Work Order ID 96777

Item Name: Grosstube Turning Detail

DART AEROSPACE LTD	Work Order:	96777
Description: Crosstube Assembly (412 High Aft)	Part Number:	D412-664-243
Inspection Dwg: D412-664-243 Rev: E		Page 1 of 2

DRAWING NO. D412-664-243	TITLE CROSSTUBE ASSEMBLY (412 HI AFT)	REV. E	DART AEROSPACE LTD ENGINEERING ORDER		D.E.O. NO. D412-664-243-E-1	SHEET NO. SHEET 1 OF 2	SCALE NTS
DRAWN	CHECKED	MFG. APPR.	APPROVED	DE APPR.			
DATE 11.03.31	DATE 11/03/31	DATE 11.03.31	DATE 11/03/31	DATE 11.03.31

**D412-664-243
ASSEMBLY DETAIL**

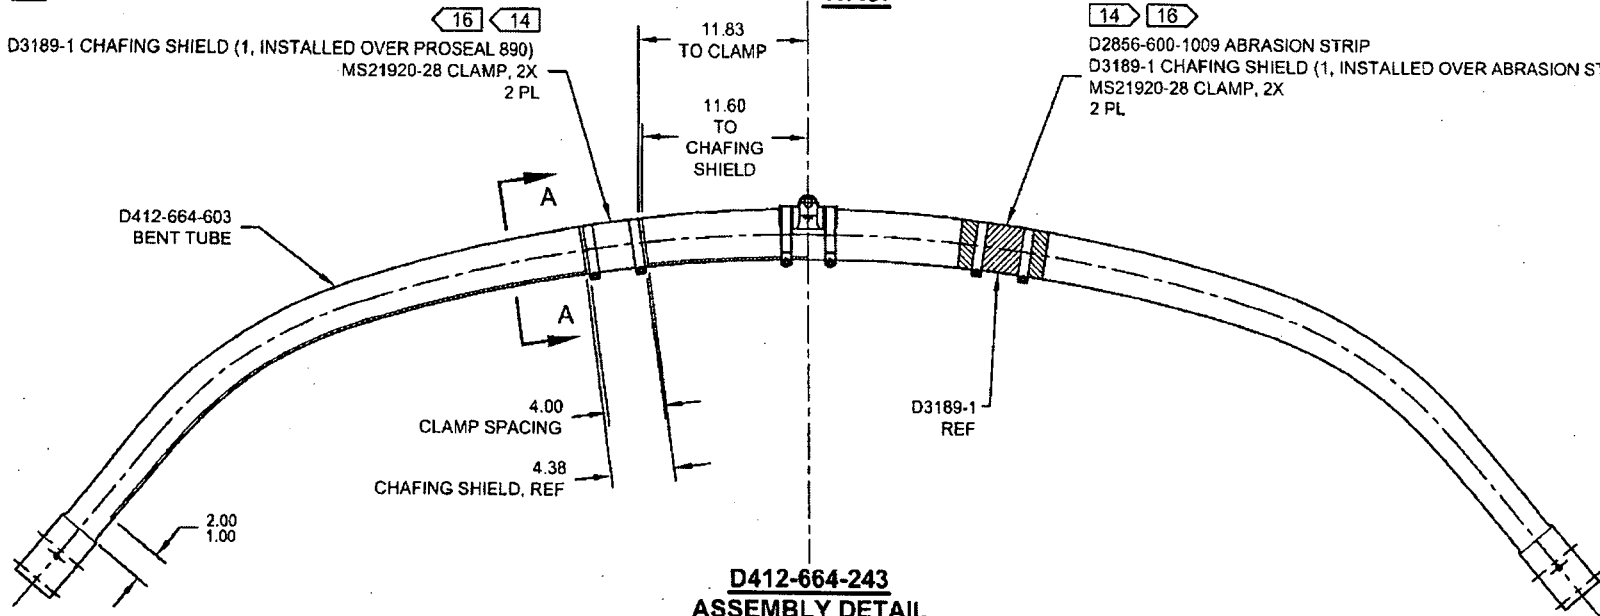
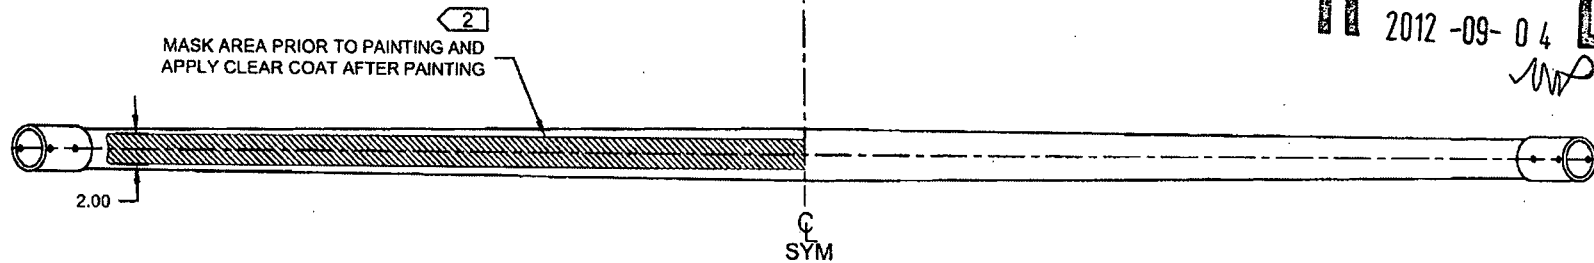
REMOVED ABRASION STRIP IN FAVOR OF A THIN LAYER OF PROSEAL 890. UPDATE INSTALLATION OF CHAFING SHIELDS AND REDUCE TORQUE TO 40-50 IN-LBS. THIS ENGINEERING ORDER SUPERCEDES DEO D412-664-243-E-1.

IS:

D3189-1 CHAFING SHIELD (1, INSTALLED OVER PROSEAL 890)
MS21920-28 CLAMP, 2X
2 PL

WAS:

D2856-600-1009 ABRASION STRIP
D3189-1 CHAFING SHIELD (1, INSTALLED OVER ABRASION STRIP)
MS21920-28 CLAMP, 2X
2 PL

SECTION A-A
CHAFING SHIELD DETAIL
VIEW ROTATED, NOT TO SCALE

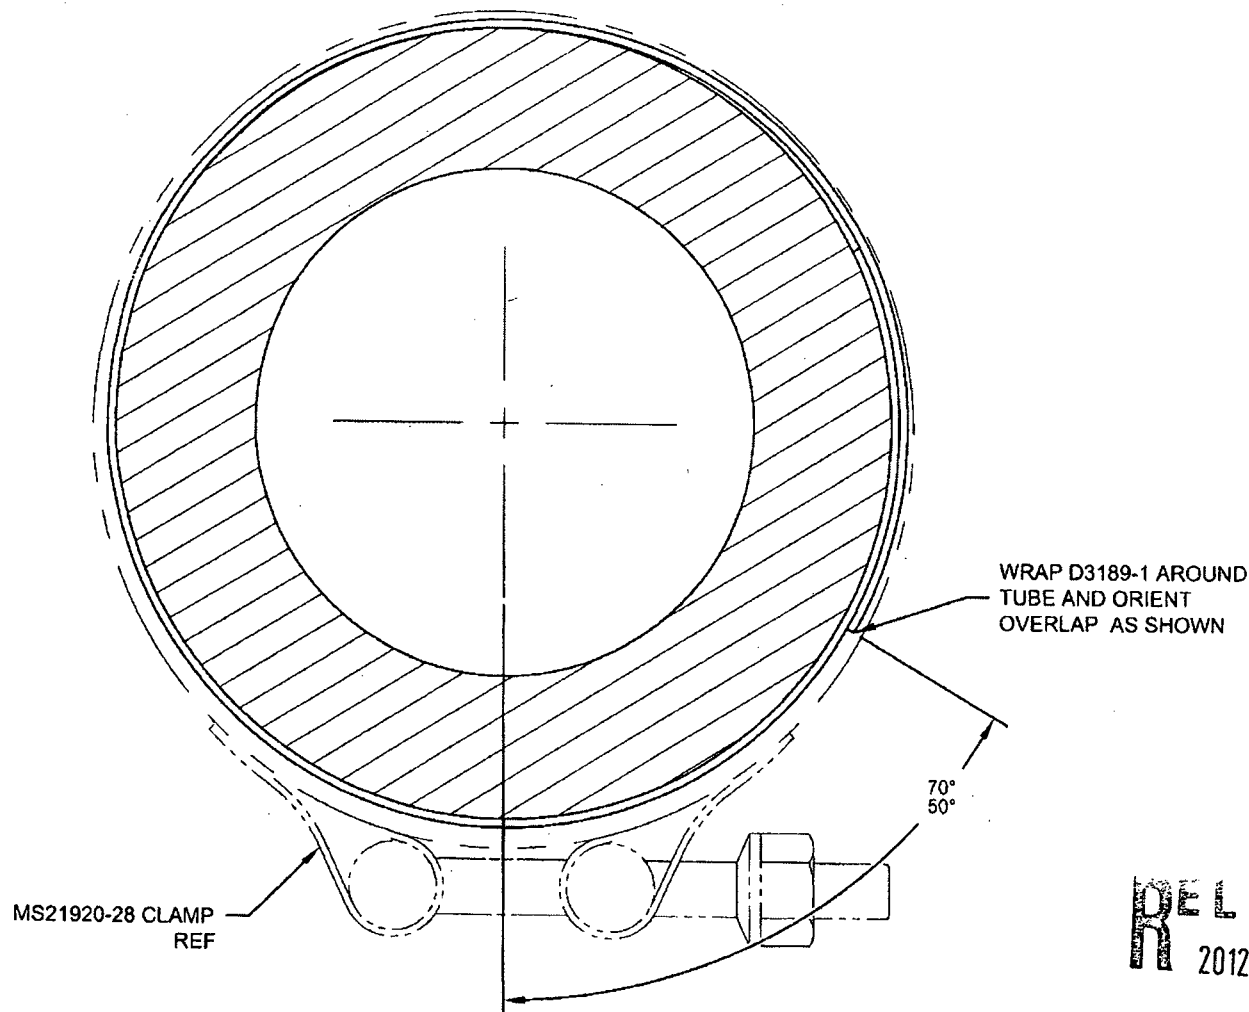
- 2) FINISH: CHEMICAL CONVERSION COAT PER DART QSI 005 4.1
PRIME INSIDE AND OUTSIDE PER DART QSI 005 4.2
MASK UNDERSIDE OF CROSSTUBE AS SHOWN (HATCHED AREA)
PAINT OUTSIDE PER DART QSI 005 4.2
AFTER PAINTING, APPLY CLEAR COAT ON HATCHED AREA
- 14) APPLY A THIN COAT OF PROSEAL 890 ON INSIDE CONCAVE SURFACE OF D3189-1 CHAFING SHIELD AND LET CURE PER MANUFACTURER'S INSTRUCTIONS. INSTALL PROSEALED D3189-1 CHAFING SHIELD ONTO CROSSTUBE BY APPLYING A THIN COAT OF PROSEAL 890 ONTO CROSSTUBE. BE SURE TO ELIMINATE ANY AIR GAPS.
- 16) TORQUE CLAMPS ON D2896-1 SUPPORT 80 TO 100 IN-LB. **TORQUE CLAMPS ON D3189-1 CHAFING SHIELD 40 TO 50 IN-LB.** ENSURE AT LEAST 1.5 THREADS SHOWING IN SAFETY AND THAT NUT HAS NOT BOTTOMED-OUT AFTER TORQUING.
